GREATER PORTLAND TRANSIT DISTRICT
Large-Sized Low Floor Transit Buses
RFP # 2022-002

ADDENDUM #3

DATE: March 7, 2022

METRO responses to proposer questions for RFP 2022-002 “Large-Sized Low Floor Transit Buses”

Tractive force diagram / Zugkraftdiagramm

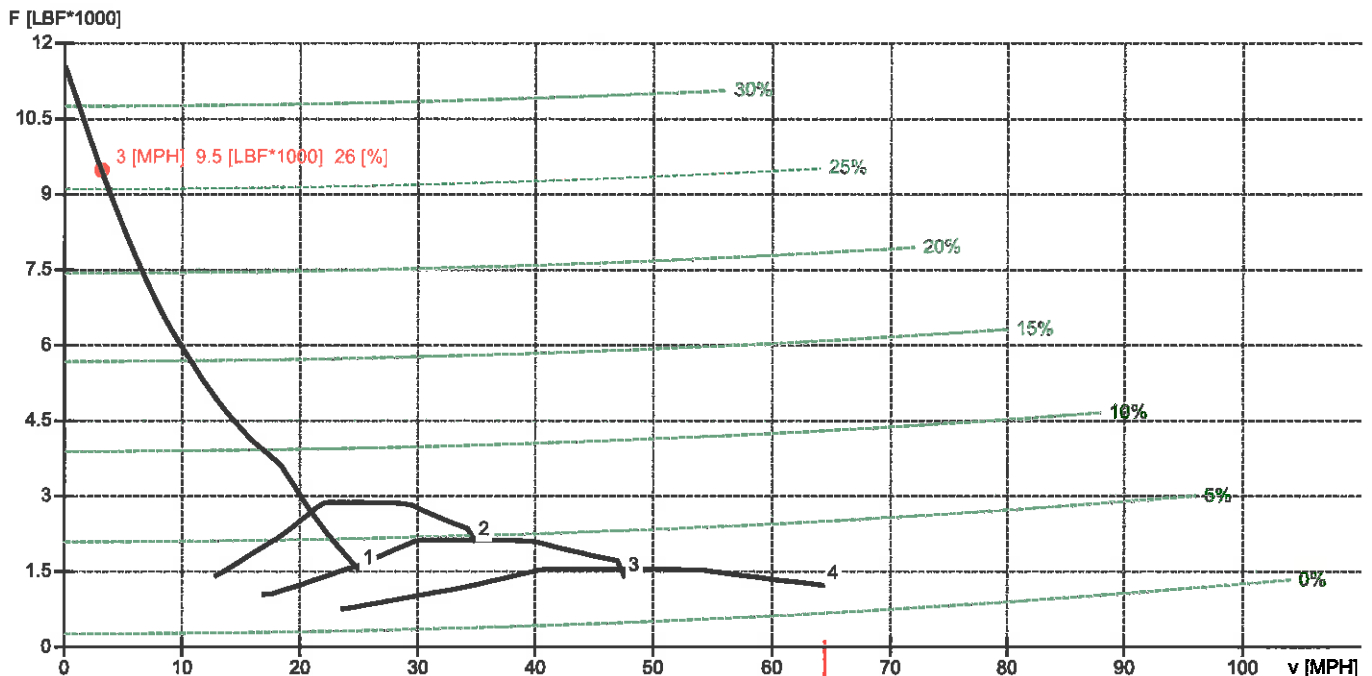
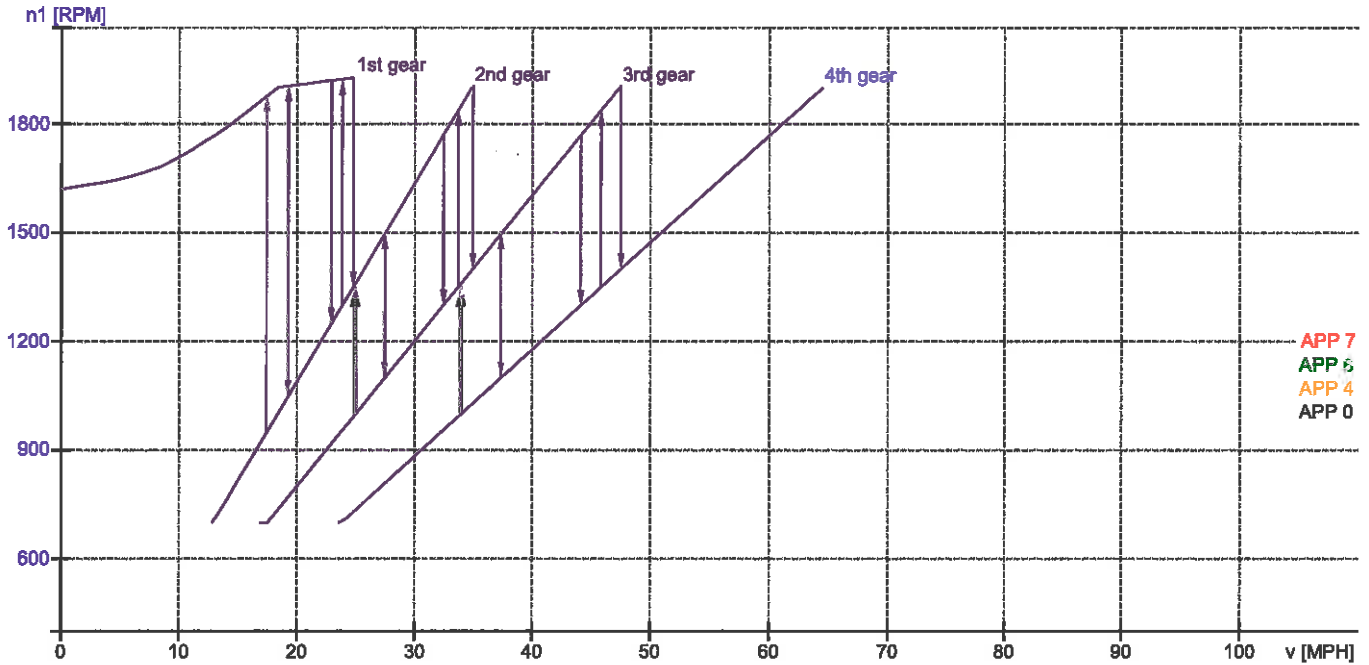
Here are the performance curves for New Flyer XD35 GPTD. I have included a table on this sheet, which will summarize the performance of these buses.

Please remember that all acceleration times are calculated from a stall start, not an idle start. For idle start times you typically add 1.5~2.5 sec to the stall start times to compensate for engine run-up.

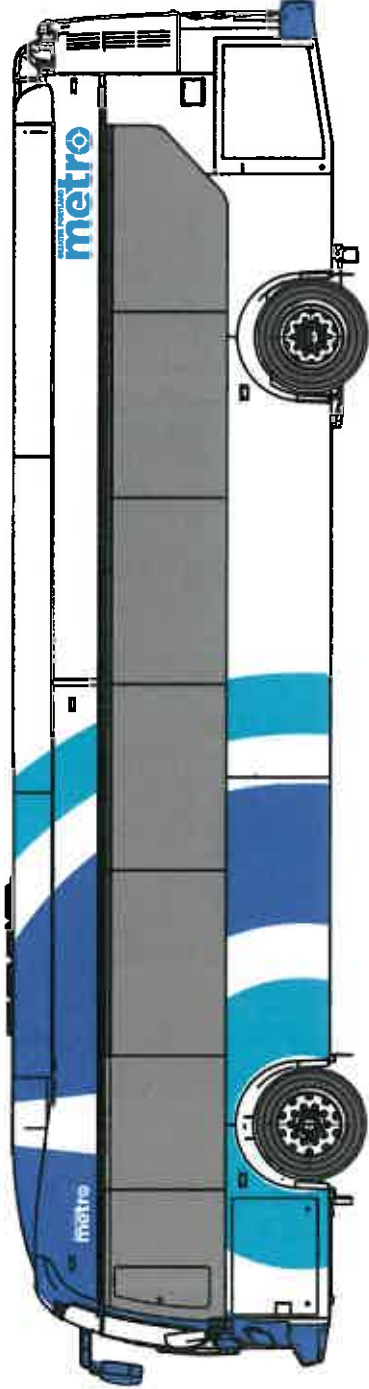
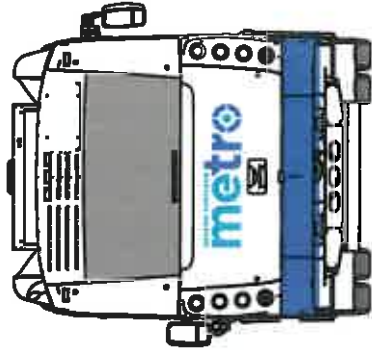
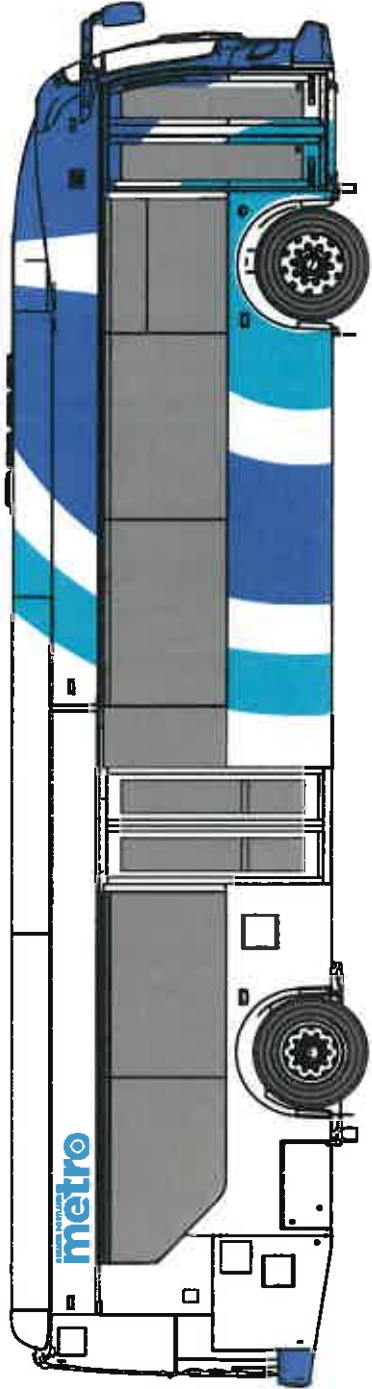
Describe Request. Include appropriate supporting documentation as outlined in the RFP:
